900 NORTH 34TH STREET

02.27.2017 | 16-009 SDCI Project #3024100

DESIGN RECOMMENDATION

NORTH FACADE DESIGN

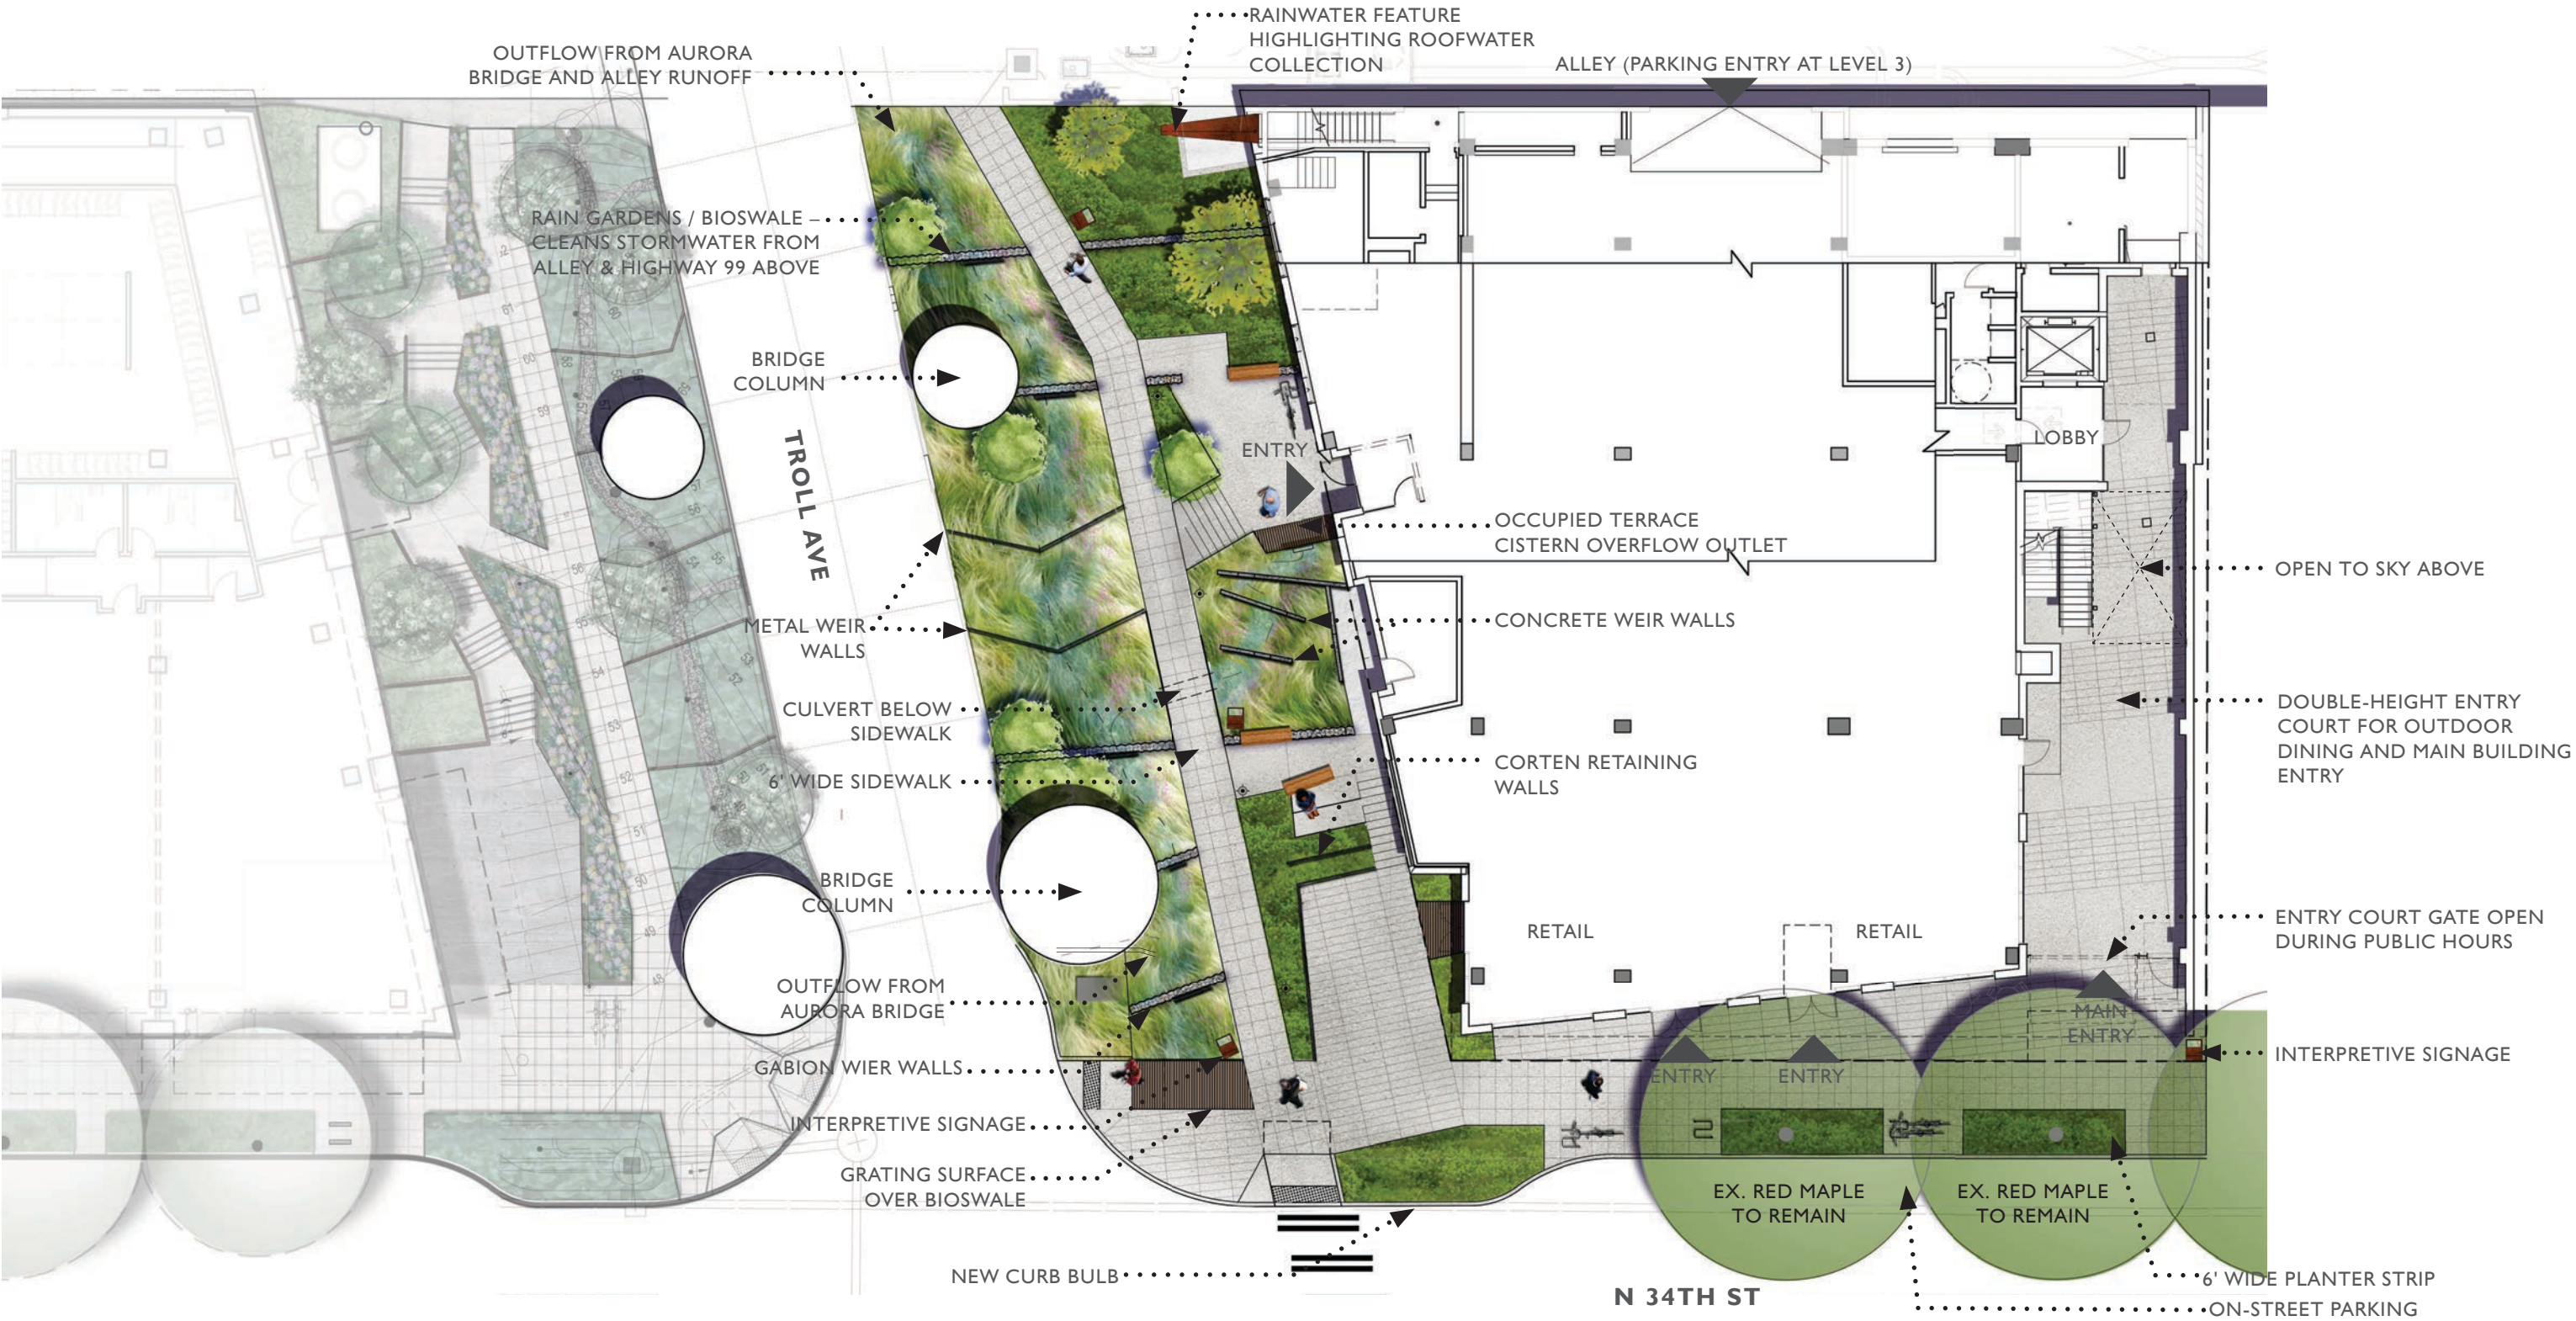
BOARD DIRECTION AT EDG: With the next submittal, provide information on how the east blank walls will be treated and further detail of the north wall at the alley.

APPLICANT RESPONSE: The proposed design highlights the water capture strategy of the Living Building Pilot Program by integrating a series of steel channels that transports rainwater from the upper roof down the north facade. This creates a visible element that breaks down the facade and integrates with the punched window pattern. Window elements were placed carefully to minimize visual conflicts to the low rise neighborhood to the north. A cable vine trellis has been integrated to screen views from the upper floors and to naturally soften the facade facing north.
